Comments on Centredale Proposed Plan

Comments to the USEPA

Proposed Plan for the Centredale Manor Restoration Project

February 2012

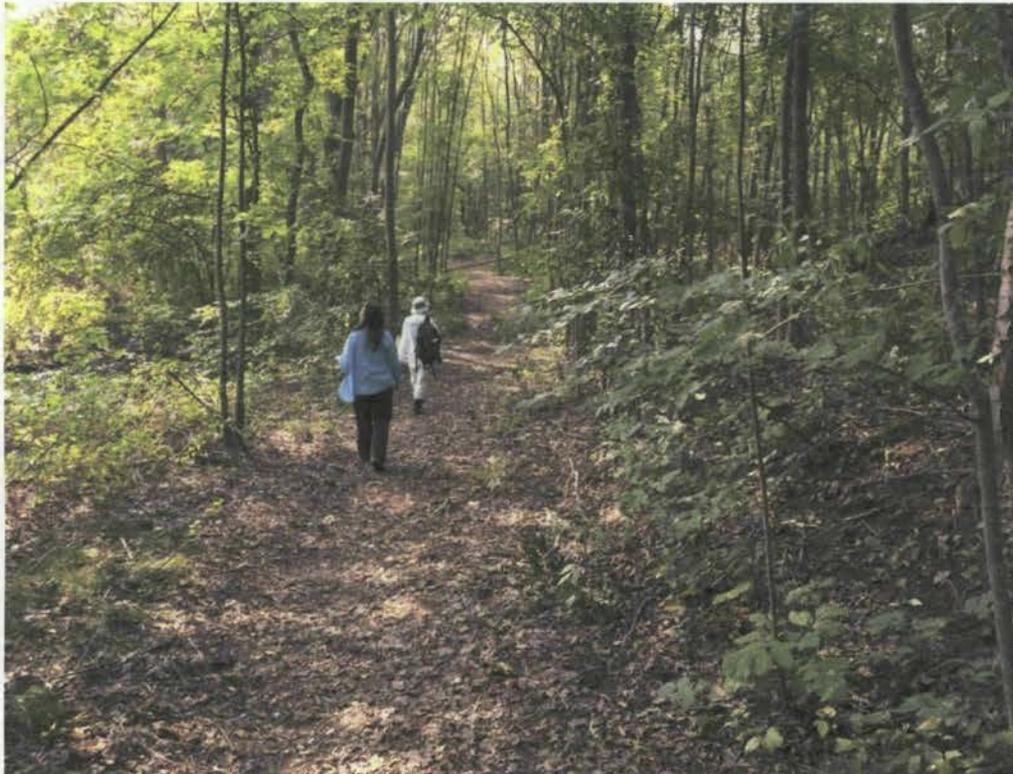
- f. While we are pleased to learn that the USEPA intends to use the RIDEM Direct Exposure Criteria as the soil remedial objective for the Oxbow, however we are concerned about the USEPA's understanding of the human activities in the Oxbow. The USEPA's information appears to be limited to observations of surface litter/debris and surface water elevation. We suspect that USEPA's understanding of the current human activities in the Oxbow may be inaccurate and that the USEPA's use of the river's flood plain may not be appropriate as a consideration regarding the areas where people are most likely to congregate. We have consistently observed a greater level of youth activity in the Oxbow during the summer, when the river levels are at their lowest and the Oxbow at its driest. During our visits to the Oxbow we have observed evidence of: youths using the area as a gathering place, fishing, hunting, camping and all-terrain vehicle use. Please refer to the attached photos (1 through 5) which depict evidence of some of these activities.

Photo 6 – Water Collecting Behind Allendale Dam In Mill Sluiceway

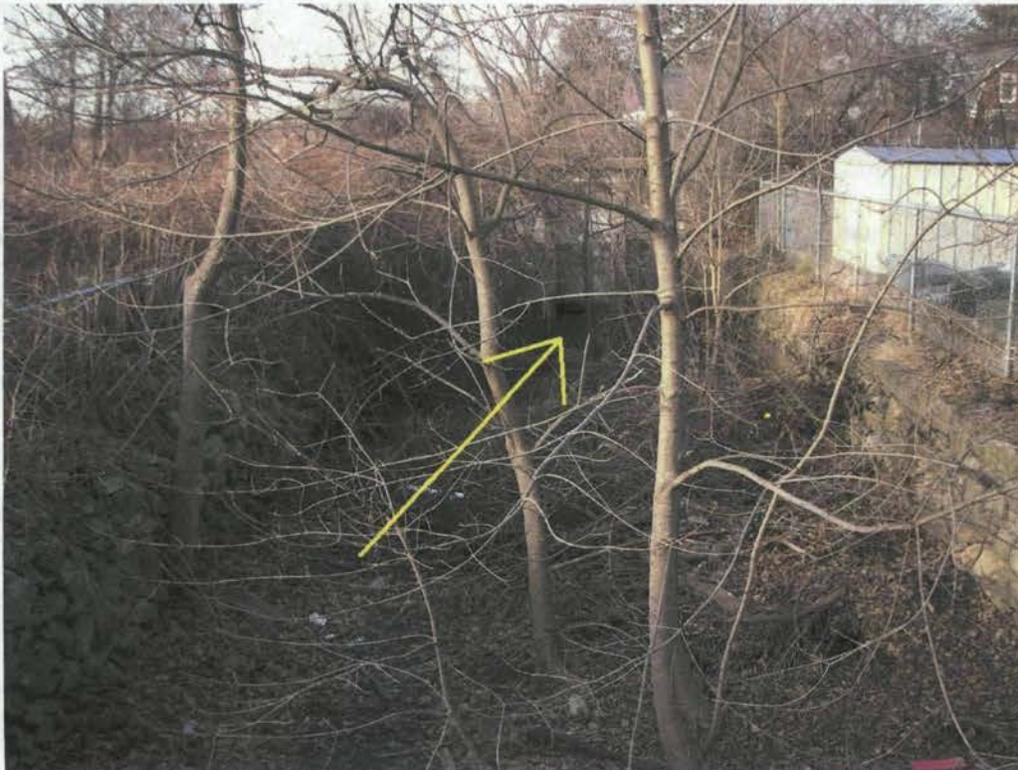
20. We suggest that after the removal of impacted sediment from the Allendale Mill sluiceway, that the portion of the sluiceway between Allendale Avenue and the Allendale Pond Dam be filled to surface grade and compacted with suitable material so as to avoid this channel becoming a potential source of floodwater into the Mill at Allendale condominiums. It is important to note that it is common to observe water ponding at the toe of the dam (see Photo 6).
